# Access Compliance Report

Intersection ID: 16558	Main Street: BUCKNELL_AV	Cross Street: QUEENS_RD_WEST	Location: E
ADA ID: 0B7183F3DD01	Ramp Type: Perp	Initial Pass/Fail: Fail	Overall Compliance: No
Severity Score: 41.25			
Codes/Mitigation Info/Possible Solution		Field Measurements/Component Compliance

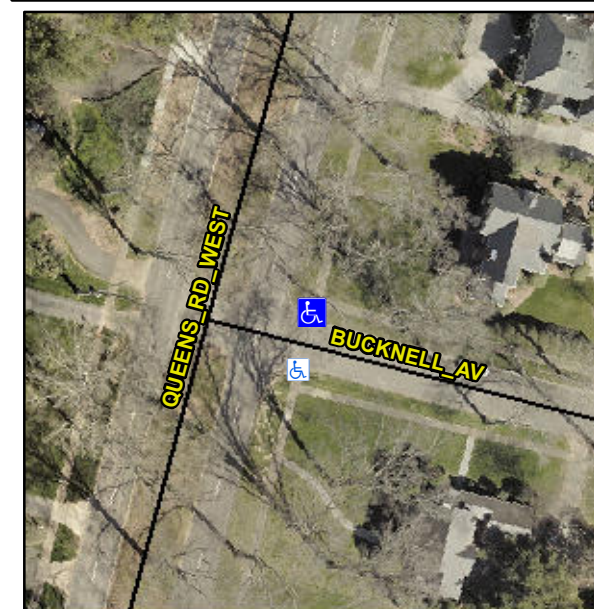
**Not Found, R304.2.2, R304.5.3, R302.7**

Compliance	Description	Data	Compliance	Description	Data
N/A	Ramp Length (in)	90.0	No	Ramp Slope (%)	12.8
Yes	Ramp Width (in)	59.5	No	Ramp XSlope (%)	4.4
N/A	Flare Type LT	N/A	N/A	Flare Type RT	N/A
N/A	Flare Slope LT (%)	N/A	N/A	Flare Slope RT (%)	N/A
N/A	Flare Traversable LT?	N/A	N/A	Flare Traversable RT?	N/A
N/A	Landing Length (in)	N/A	N/A	DWS Provided?	N/A
N/A	Landing Width (in)	N/A	N/A	DWS Contrast?	N/A
N/A	Landing Slope (%)	N/A	N/A	DWS Length (in)	N/A
N/A	Landing X Slope (%)	N/A	N/A	DWS Full Width?	N/A
N/A	Landing Curb? (Y/N)	N/A	N/A	DWS Offset (in)	N/A
N/A	Shared Landing?	N/A			
N/A	Gutter Ponding?	N/A	N/A	Gutter Slope (%)	N/A
N/A	Gutter Lip Ht (in)	N/A	N/A	Gutter X Slope (%)	N/A
N/A	Painted X Walk1?	No	N/A	Painted X Walk2?	N/A
	X Walk 1 Direction	To SW		X Walk 2 Direction	N/A
N/A	X Walk 1 Width (in)	N/A	N/A	X Walk 2 Width (in)	N/A
	X Walk 1 Slope (%)	3.4		X Walk 2 Slope (%)	N/A
	X Walk 1 X Slope (%)	0.2		X Walk 2 X Slope (%)	N/A

**Remove & Replace Entire Ramp.**
